Work Order ID 144069

Item Name: Quick Release Heli-Utility-Basket™ Long, HD Lid, Spacepod™/Squirrel Cheek Comp.

DART SERVICE INSTRUCTION

TO AMEND INSTALLATION INSTRUCTIONS D350-607-3 Rev.D,
INSTALLATION INSTRUCTIONS D350-607-4 Rev. C AND
INSTRUCTIONS FOR CONTINUED AIRWORTHINESS ICA-D350-607 REV. 6
REF TCCA STC: SH94-14
REF FAA STC: SR00213NY
REF EASA STC: EASA.10016996
REF BRAZILIAN STC: 2007S03-03/-04/-05/-06

FIGURE 1: INSTALLATION OF D4775-041 FWD STRUT

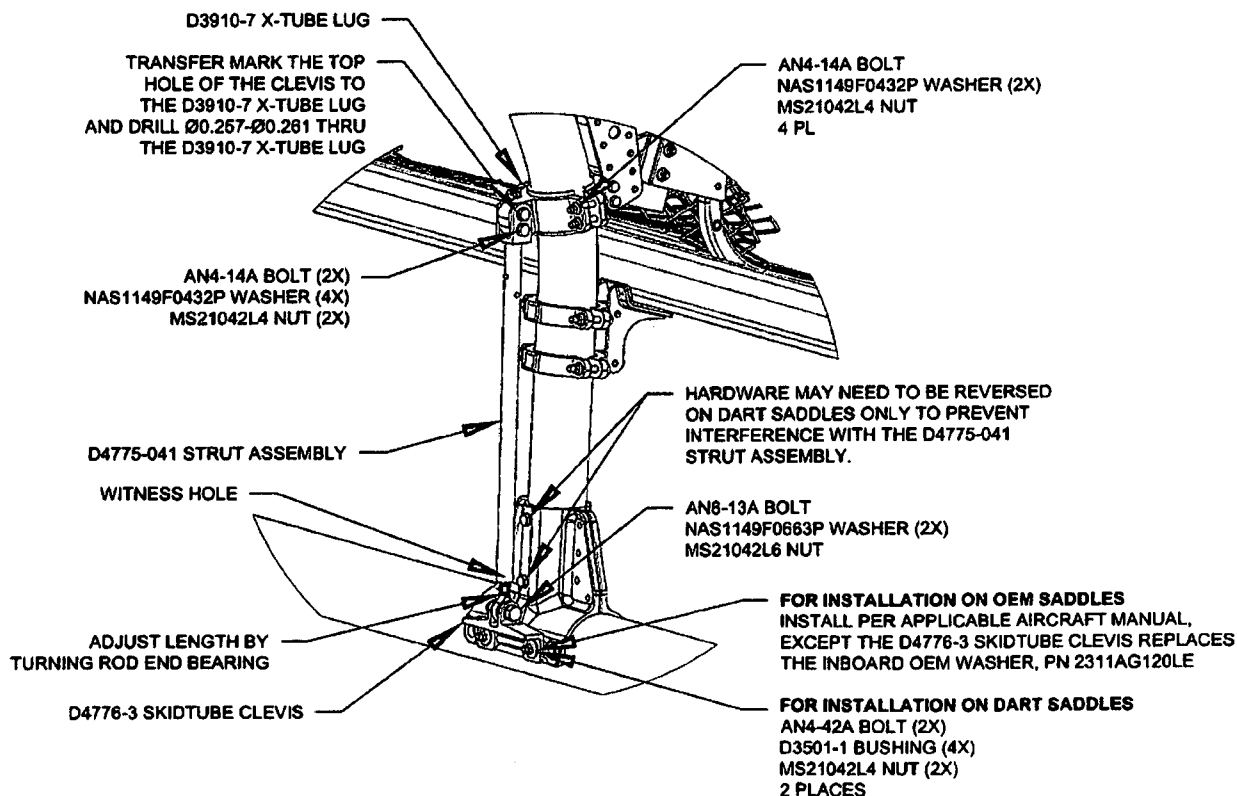
3.1 Substitute the Forward Lower D3910-5 X-Tube Lug with the D3910-7 X-Tube Lug as shown in Figure 1.

3.2 Install the forward D4775-041 Strut Assembly. Transfer mark from the upper hole on the clevis of the D4775-041 Strut Assembly to the D3910-7 X-tube Lug and drill thru the lug $\varnothing 0.257$ - $\varnothing 0.261$ as shown in Figure 1. Touch up chemical conversion coating per MIL-DTL-5541. Check the witness holes located at the bottom end of the D4775-041 Strut Assemblies to ensure that the thread from the rod end extends past the witness hole. **Torque MS21042L4/-4 nuts to 50-70 in-lbs (5.7-7.9 N-m). Torque MS21042L6/-6 nuts to 160-190 in-lbs (18.1-21.5 N-m).**
